**M54 to M6 Link Road**

**TR010054**

## **8.3 Notification of Proposed Scheme Changes**

<b>Planning Inspectorate Scheme Reference</b>	TR010054
<b>Application Document Reference</b>	8.3
<b>Author</b>	M54 to M6 Link Road Project Team and Highways England

Drawing Title  
**SCHEME CHANGES DRAWING FOR THE INSPECTORATE SHEET 1**

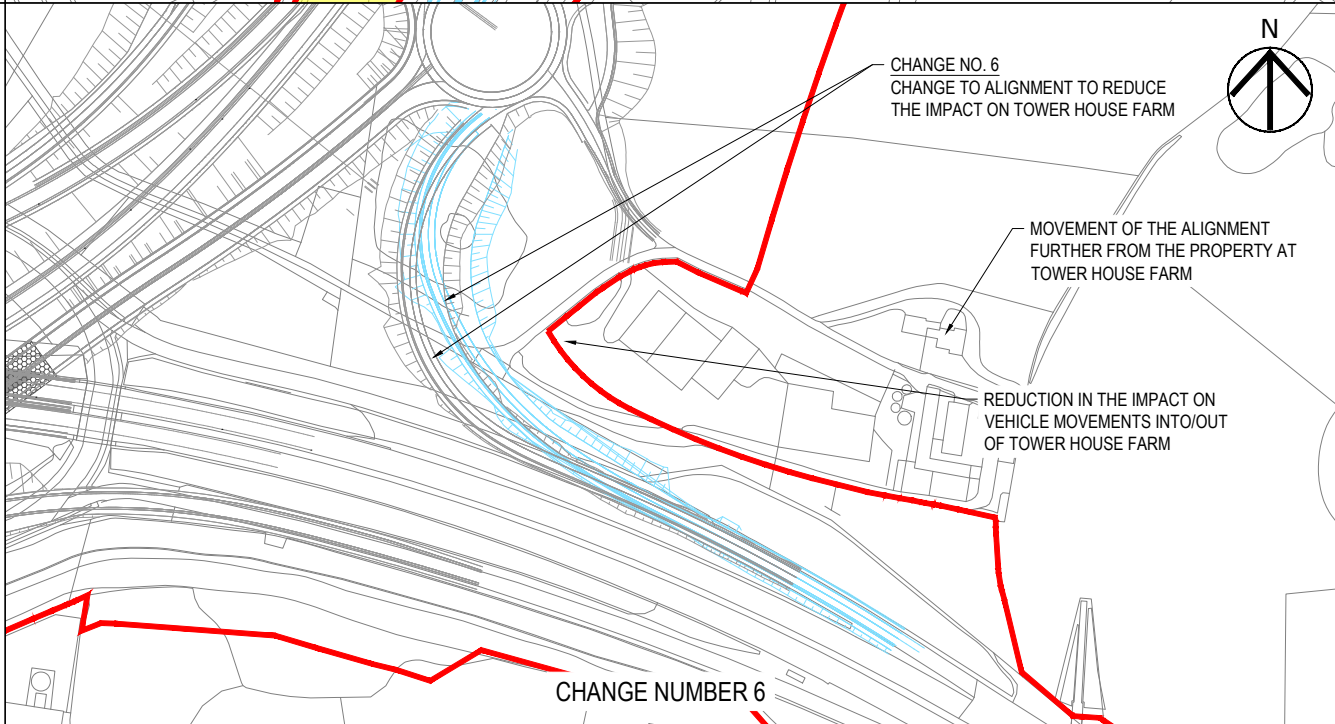
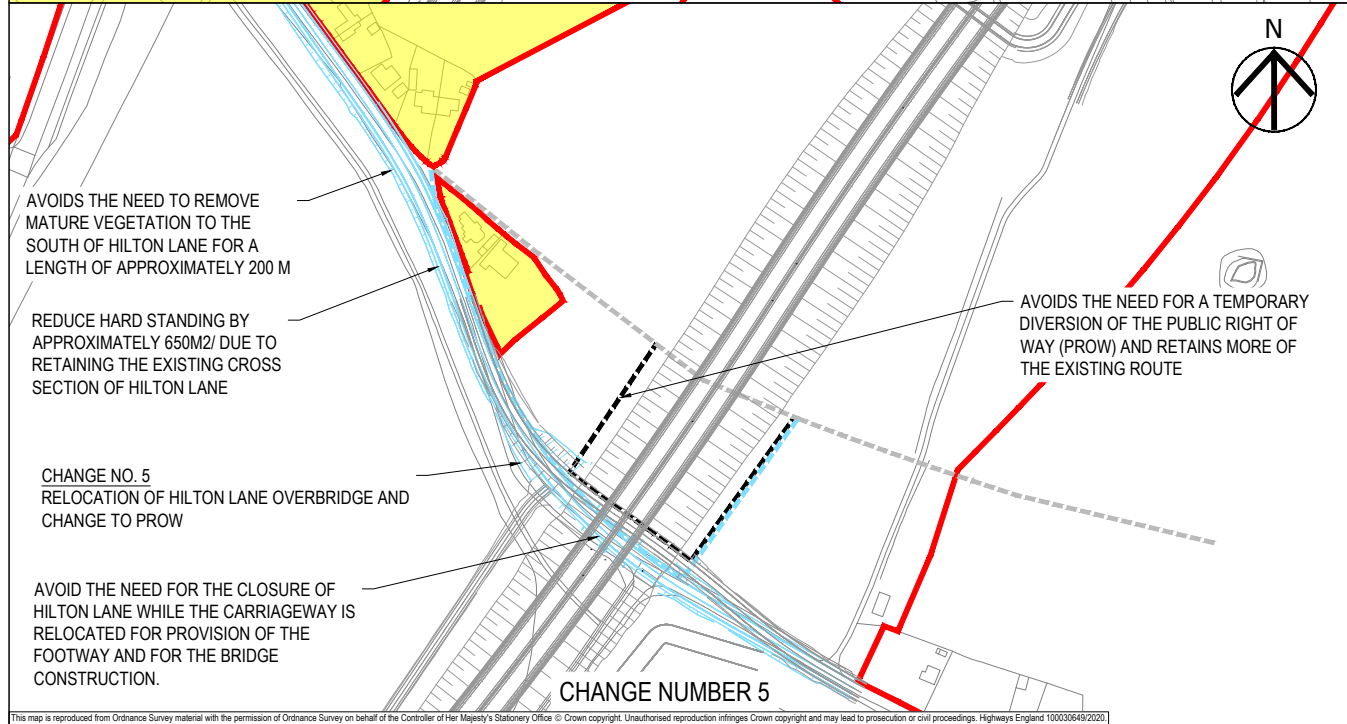
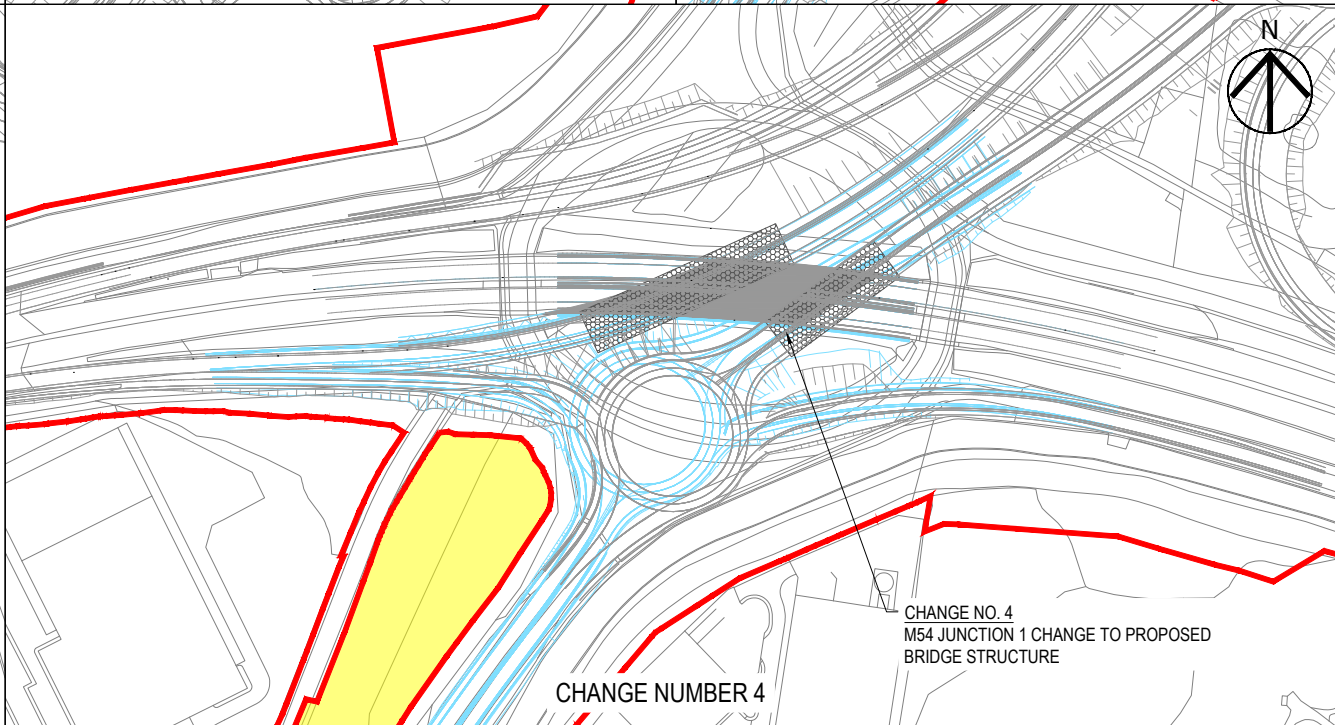
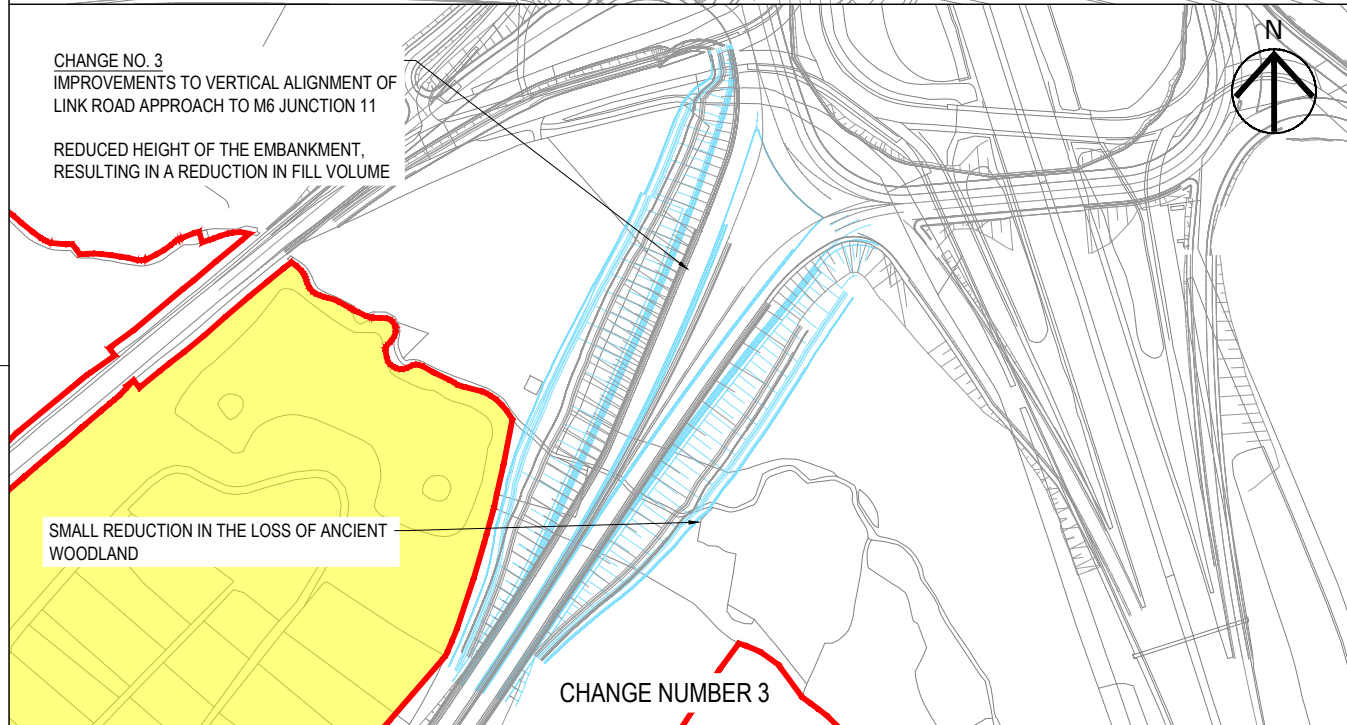
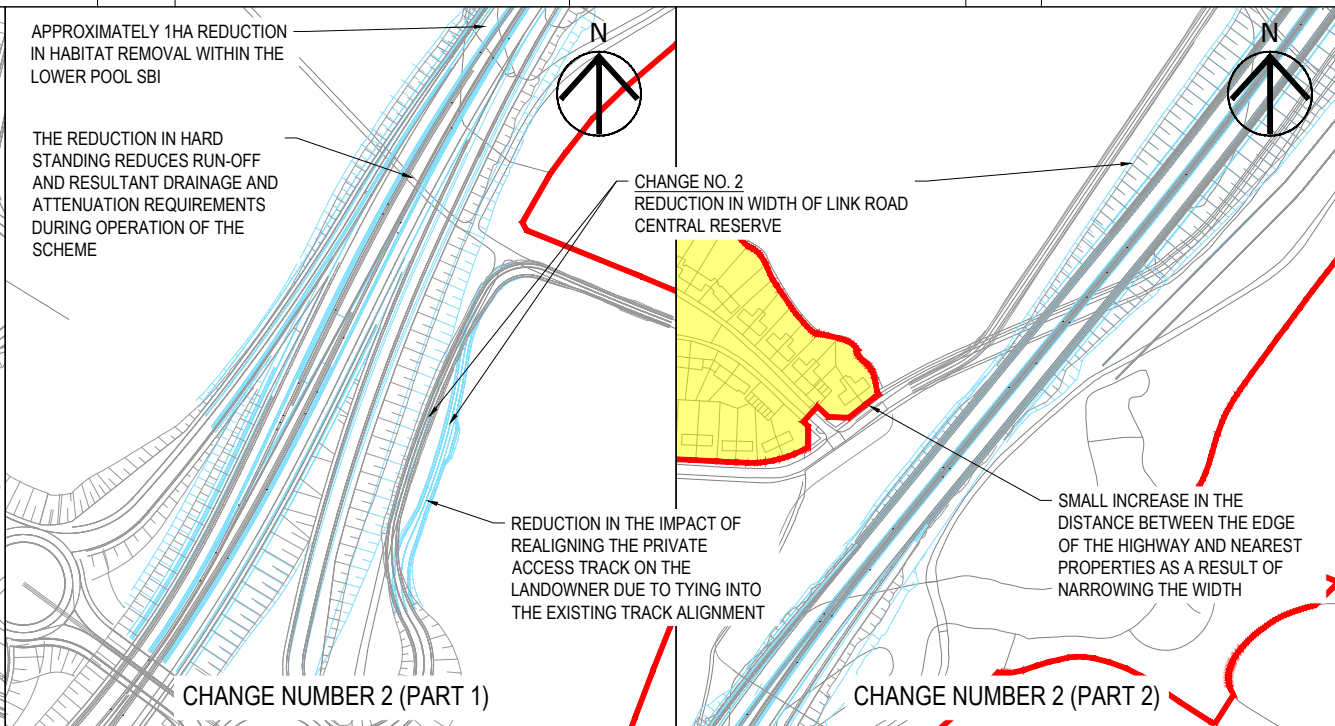
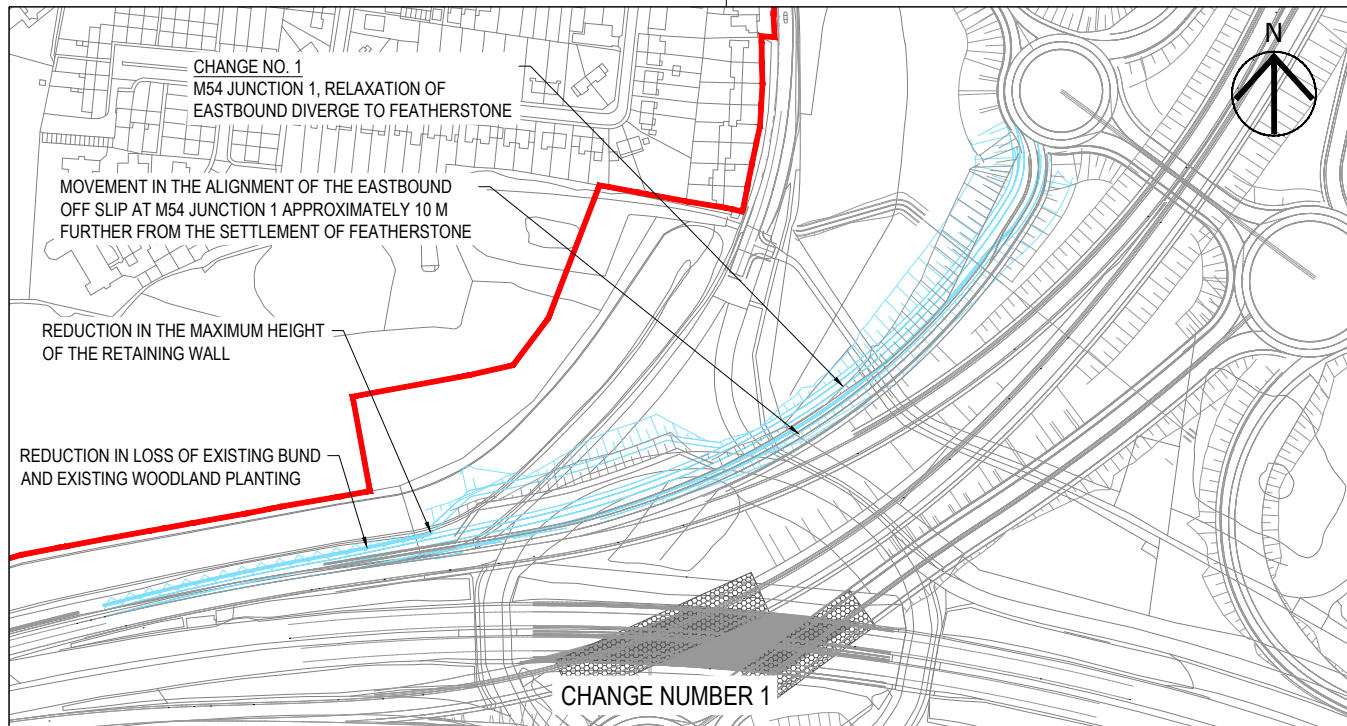
2.4.1 This change proposes to omit the near straight from the M54 Junction 1 eastbound diverge to Featherstone, reducing the length of the slip road. This allows the diverge to be relocated further downstream and reduces the extent of widening through the bund. The change has arisen as a result of continued design refinement which has identified improvements to the Scheme and a reduction in environmental impacts.

2.5.2 The proposed change would reduce the footprint of the link road by reducing the width of the central reserve from 4.5 m to 3.0 m along the length of the new link road and reducing the width of the verge area by putting the surface water channel in the verge rather than adjacent to it.

2.6.2 This proposed change would alter the approach to M6 Junction 11 by reducing the height of the approach to the junction. This change reduces the height of the embankment by approximately 0.7 m.

2.7.1 This proposed change would reduce the complexity and buildability issues associated with the main structure at Junction 1 by separating the main structure (currently 112m span) into two simpler structures. This enables the structures to be constructed in the site compound to the north-east of the junction and moved into position rather than constructed in the location of the new bridges.

- 2.8.1 This change proposes to build Hilton Lane bridge off-line (north of its current location) and retain the route of the Public Right of Way (PRoW) (Shareshill 5) across adjacent land rather than route it alongside the link road and is proposed following development of construction phasing and buildability reviews.

2.9.1 This change proposes to alter the alignment of the slip road between Featherstone Interchange eastern roundabout and the M54 eastbound further west from its current position. This change will address concerns raised by the landowner at Tower House Farm that the scheme will adversely impact access to the site.
